APPENDIX 3:

COUNCIL OFFICER EVIDENCE

SUBJECT: **LUC-2020-293**
20 Bay Road. Warrington.
LA Comments

SUBJECT: **LUC-2020-293 20 BAY ROAD HERITAGE COMMENTS**

Figure 7: View to the north from near the northern extent of the proposed stage two parking area.

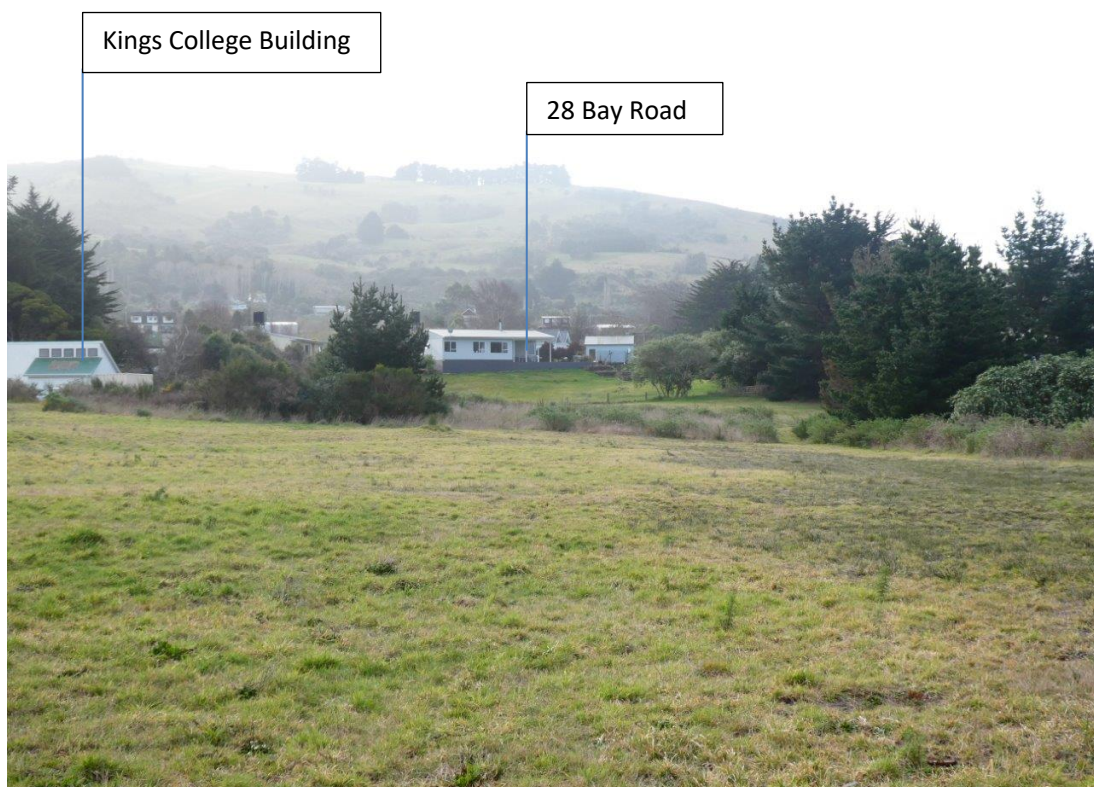
It is also recommended that additional locally appropriate coastal planting is provided at the western end of the southernmost parking rows to form a buffer to the Blueskin Bay edge of the site and associated public access/tracks.

Map showing an estimate of the proposed excavation areas as described in the application and RFI documents.

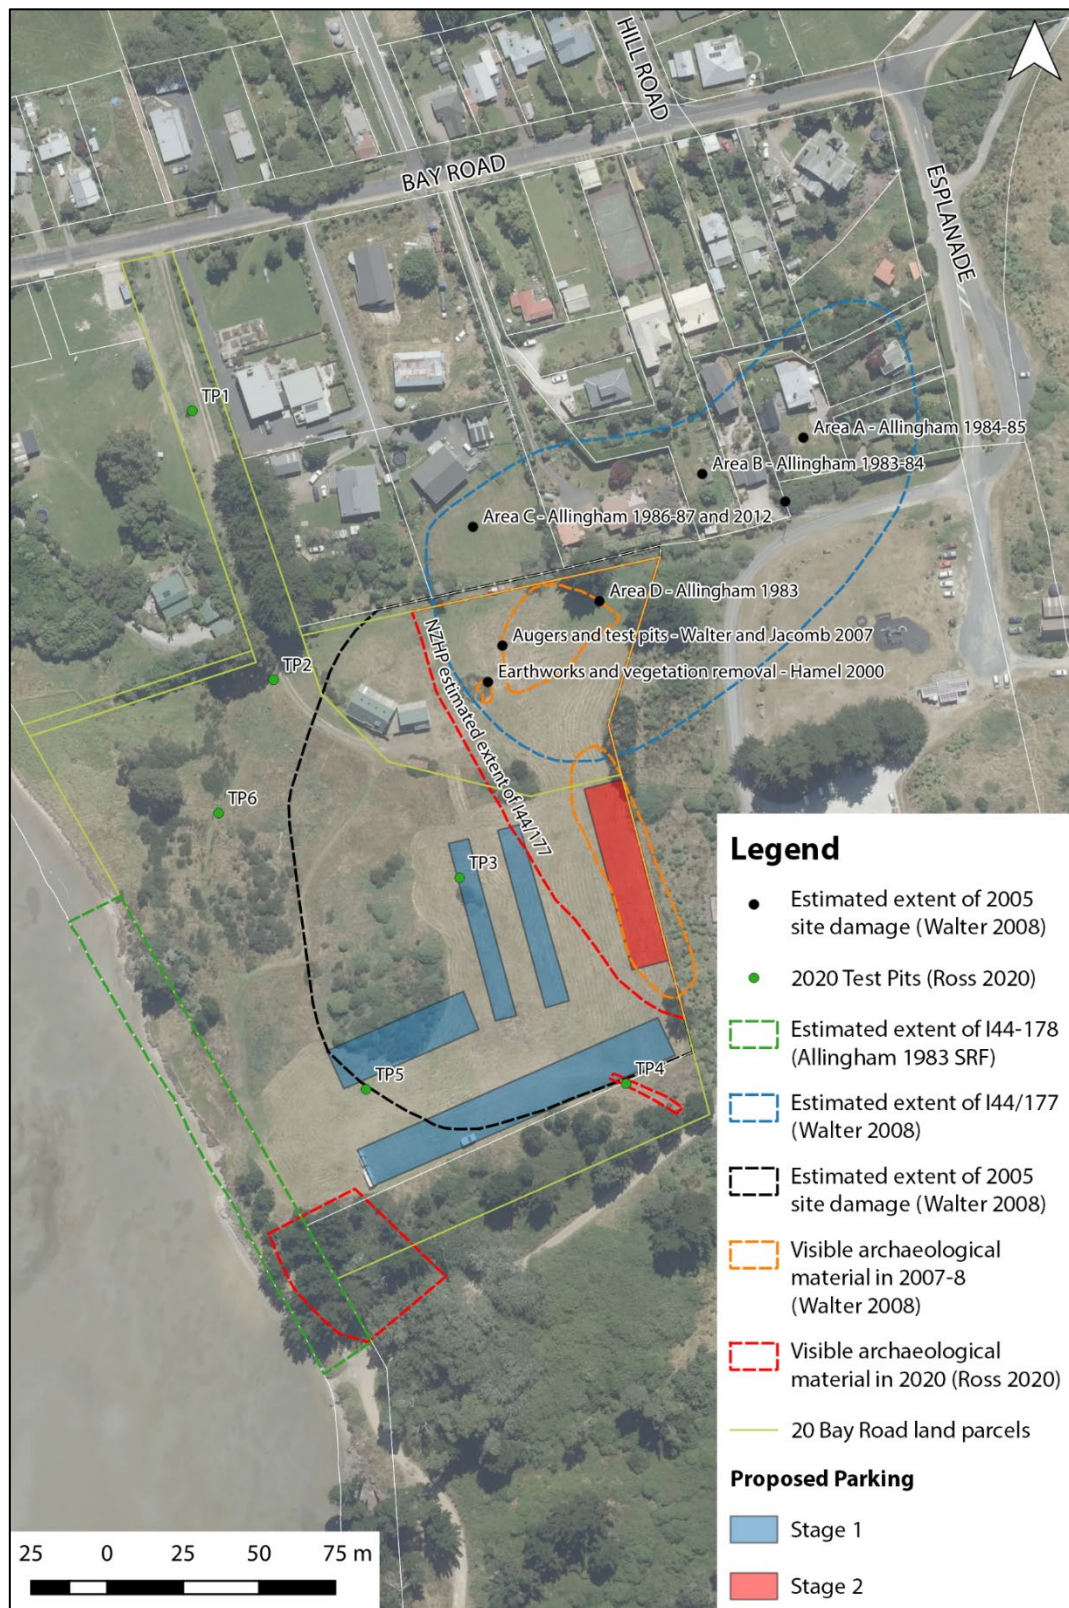
- 250mm deep excavation along the length of the driveway from Bay Road to form a gravel surface.
- Approximately 50mm deep excavation in circulation areas to form the proposed 'Type 1' pavement. The extent of this work has been estimated as it is not clearly defined beyond "near the kiosk/transition from the granular accessway onto the grassed areas at the head of each lane."
- Approximately 100mm deep excavation for planting strips.
- Approximately 300mm deep excavation for vegetation clearance.
- Approximately 150mm deep excavation for topsoil removal along parking bays.
- An undefined amount of excavation for native underplanting in the existing trees along the southern margin of the site.

All the proposed excavation may affect previously undiscovered archaeological material at the site and will require an archaeological authority from HNZPT. This has already been noted in the NZHP report, but it is important point to emphasise as it does not appear to have been discussed in the other application documents. There is a potential for encountering previously unrecorded material considering:

Plate 5 – Indigenous saltmarsh vegetation on estuary edge adjacent to property.

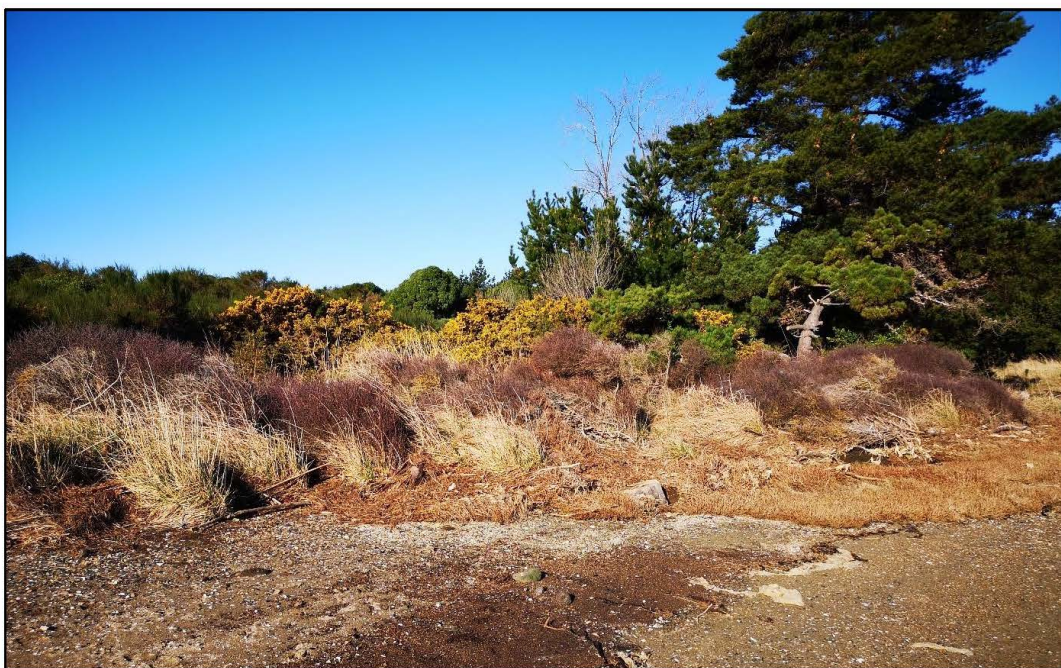
- c) Potential significant adverse effects on indigenous biodiversity in the adjacent area of indigenous saltmarsh vegetation can be anticipated and should be avoided.
